SUB-COMMITTEE ON SHIP DESIGN AND
CONSTRUCTION
1st session
Agenda item 4

SDC 1/INF.4
18 October 2013
ENGLISH ONLY

**DEVELOPMENT OF PROVISIONS TO ENSURE THE INTEGRITY AND UNIFORM
IMPLEMENTATION OF THE 1969 TM CONVENTION**

Information collected by the correspondence group

1. Article 2(8) - Length for unusual hull forms (proposed figure)

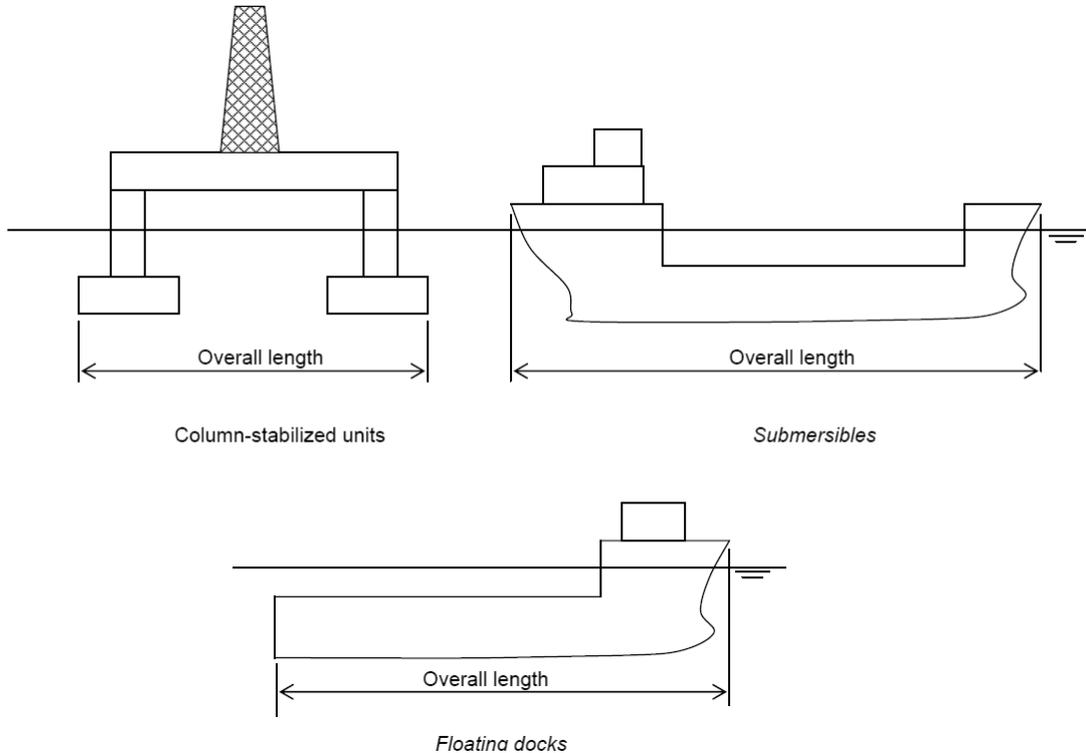
1. Article 2(8) - Length of unusual hull configurations The group evaluated replacing the existing interpretation with revised draft Interpretation A.2(8)-2, and including the associated draft figure, with 14 participants providing input. One participant proposed changing the interpretation to provide for an accompanying remark on the ITC69. Two commented to the effect that both the floating dock and submersible shown in the figure are conventional hull forms. One of these participants additionally noted that some existing submersible barges are issued load line certificates, with the well decks treated as freeboard decks, so the figure is not appropriate when applied to such ships. The revised interpretation received sufficient support, and the revisions were included in the draft circular. The figure did not receive sufficient support, and was not included.

9. Regulation 2(4) - Grates over deck openings (proposed figure)

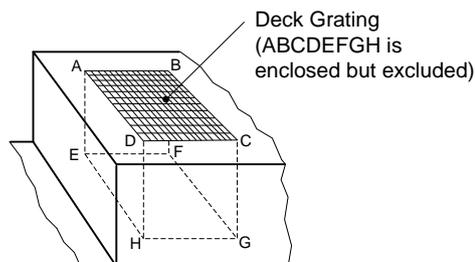
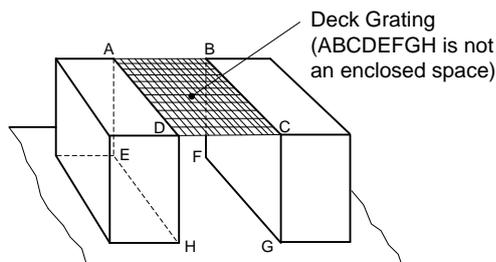
11. Regulation 2(4) - Gratings over deck openings The group evaluated proposed draft Interpretation R.2(4)-9 and the associated draft figure, with 13 participants providing input. One participant proposed including a reference to Regulation 2(5)(d). Another proposed adding a figure showing side/forward gratings, while another commented that the right hand illustration in the figure should be deleted. The interpretation received sufficient support, and was included in the draft circular as Interpretation R.2(4)-8. The figure did not receive sufficient support, and was not included.

10. Regulation 2(5) - Spaces opposite side openings (proposed figure)

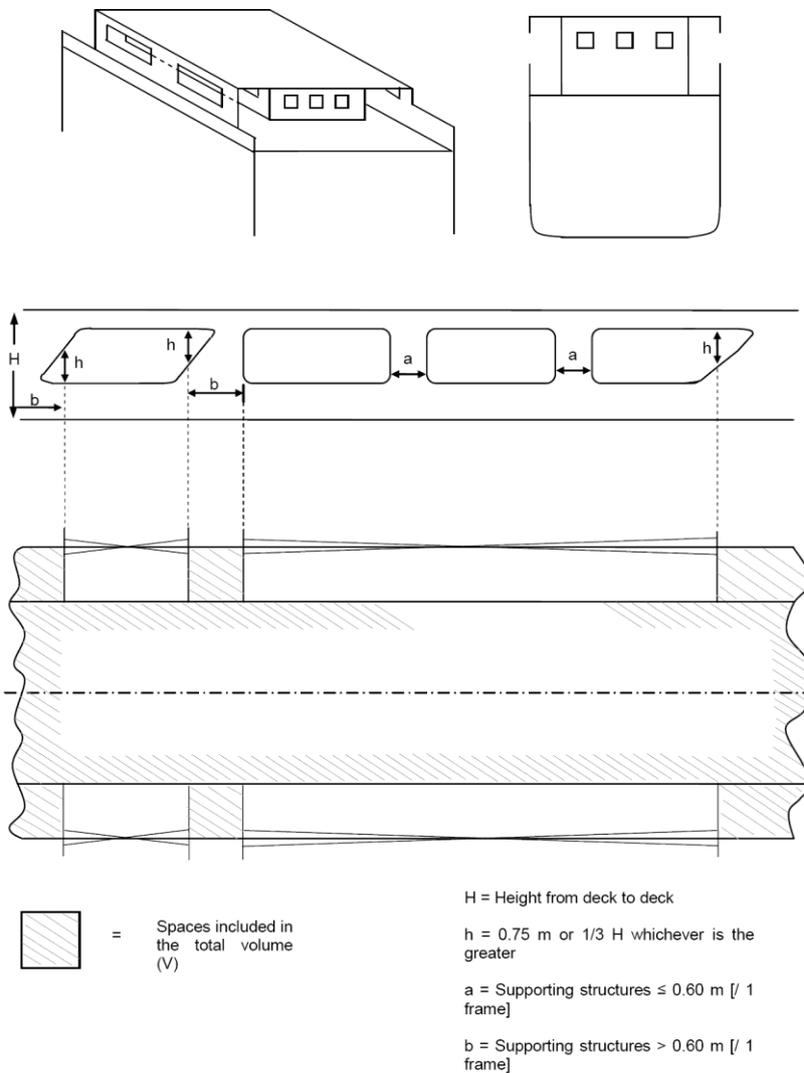
15. Regulation 2(5) - Spaces opposite side openings The group evaluated replacing the existing figure accompanying Interpretation R.2(5)-1 with a revised figure, with 14 participants providing input. Six participants questioned, requested changes to, or disagreed with the 0.6 m [1 frame] criterion indicated in a note accompanying one of the illustrations. In commenting on the related deck structure height requirement, one participant shared a related "common understanding" document with the group. Another expressed the view that passageways should be exempt in all cases where non-weathertight, and that the treatment under this regulation unfairly impacts yachts, where styling and shapes do not fit well with the regulation. The revised figure did not receive sufficient support for inclusion in the draft circular.

11. Regulation 2(5) - Deck breadth and end openings (proposed figure)

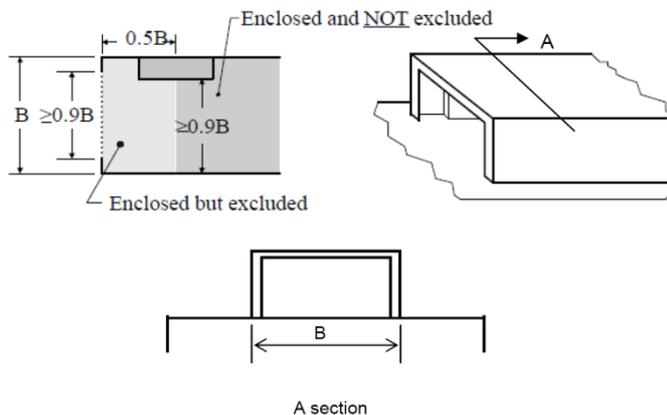
17. Regulation 2(5) - Deck breadth and end openings The group evaluated the draft figure to accompany Interpretation R.2(5)-6, with 14 participants providing input. One participant questioned the interpretation agreed to at SLF 55, for smaller structures such as those depicted in the figure, commenting that it would be better to apply this interpretation only when the structures are not side-to-side due to side passageways. Another suggested additionally applying height or area restrictions to this configuration (e.g. 0.75H or 0.9B X 0.75H). Another commented that the figure does not meet basic drafting requirements for consistency of views. The figure did not receive sufficient support for inclusion in the draft circular.

14. Regulation 2(5)(c) - Deck structure heights and side openings (proposed interpretation and figure)

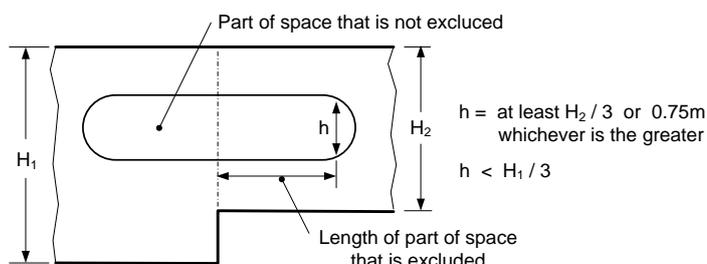
21. Regulation 2(5)(c) - Deck structure heights and side openings The group evaluated proposed draft Interpretation R.2(5)(c)-1 and the associated draft figure, with 13 participants providing input. One participant expressed preference for a previously favoured, more generous, proposal. Neither the interpretation, nor the figure, received sufficient support for inclusion in the draft circular.

The height of the opening should be evaluated by the height between the continuous/complete decks in each tier. Stepped decks should be treated in separate parts with the height being used as appropriate for the part. With a sloping deck, the space can be excluded until the point at which the 1/3 height (H) or 0.75 m criterion applies.

15. Regulation 6(3) - Cargo and buoyant spaces open to the sea (proposed figure)

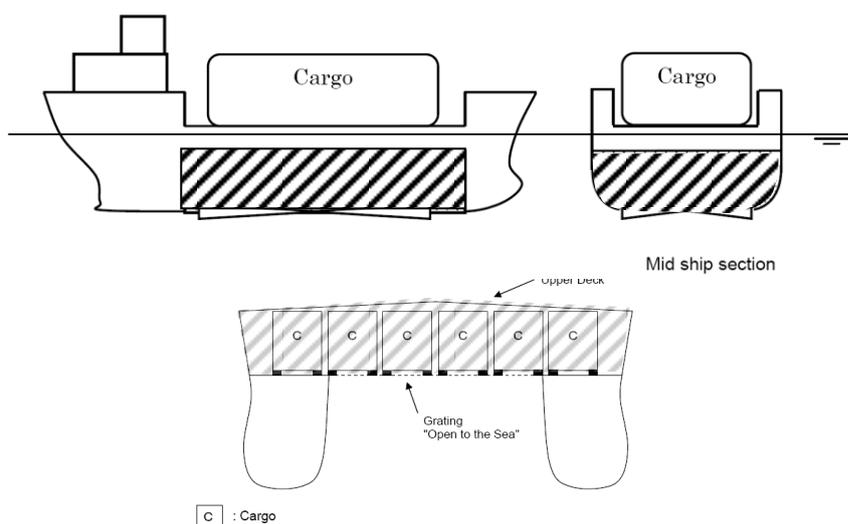
23. Regulation 6(3) - Cargo and buoyant spaces open to the sea The group evaluated the draft figure to accompany Interpretation R.6(3)-3, with 13 participants providing input. Two participants commented that the illustrations should be clarified to indicate whether the shaded areas are included in tonnage. One participant commented that such spaces should be bounded on three or more sides. Another maintained that the use of the term "buoyancy" in the interpretation could lead to overextension. The figure did not receive sufficient support for inclusion in the draft circular.

18. Novel craft interpretation - Dockships (proposed revised figure)

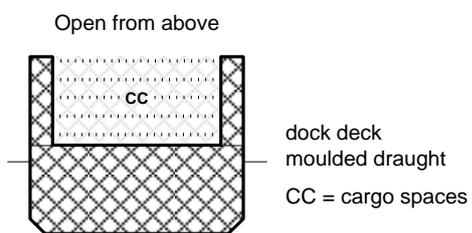
26. Novel craft interpretations - Correction to dockship figure The group evaluated replacing the existing figure accompanying Interpretation N.2-1, with a revised figure, with 13 participants providing input. One participant commented that the revised figure more typically represents a dockship. In not supporting this change, another commented that the cross-hatched area in the illustration must be included in tonnage. The revised figure did not receive sufficient support for inclusion in the draft circular.
